JOB NO. 313 DRG. NO. 51

PROJECT NO. BHF-030-2(19)S STATE PROJECT NO. BRIDGE-20
MATERIAL AASHTO M270 Gr 36 ELECTRODES: SEE PROC. HOLES: 13/16" ø SHOP BOLTS: —
SURFACE PREP. & PAINT:

DESCRIPTION: DIAPHRAGM DETAILS
JOB: VERMONT 15 OVER LAMOILLE RIVER CAMBRIDGE, VT.
CUSTOMER: BECK & BELLUCCI

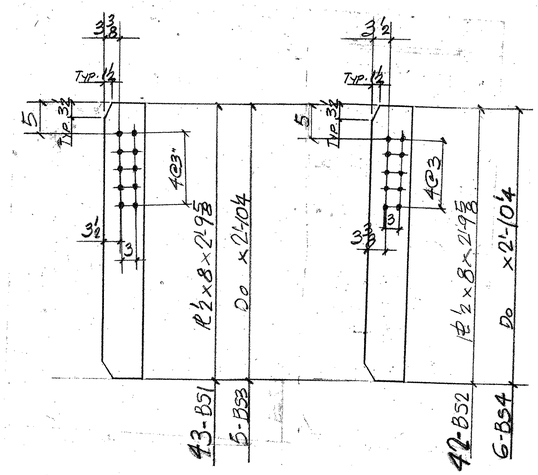
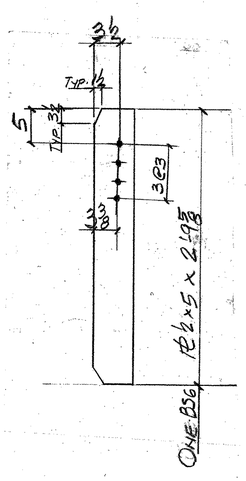
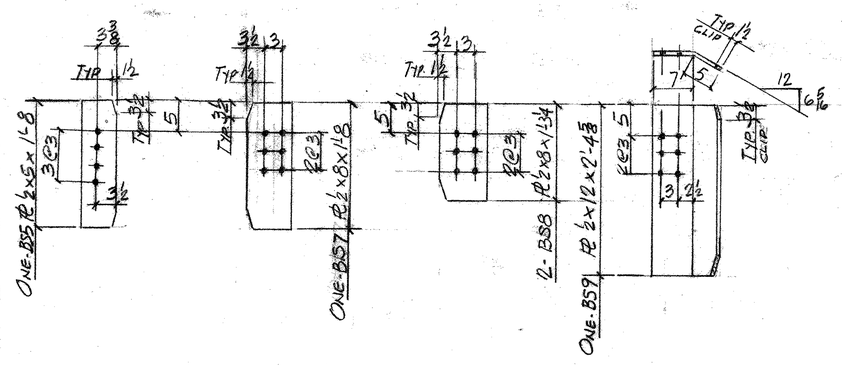
FIELD NOTE
4" HAS BEEN ADDED TO LENGTHS OF BEARING STIFF'S FOR FIELD FIT-UP.

{PLEASE ADVISE IF THIS IS SUFFICIENT

RECEIVED
CK'D BY DRP OK'D BY
FEB 21 2007
RESUBMIT ____ APPROVED ✓
BY DATE
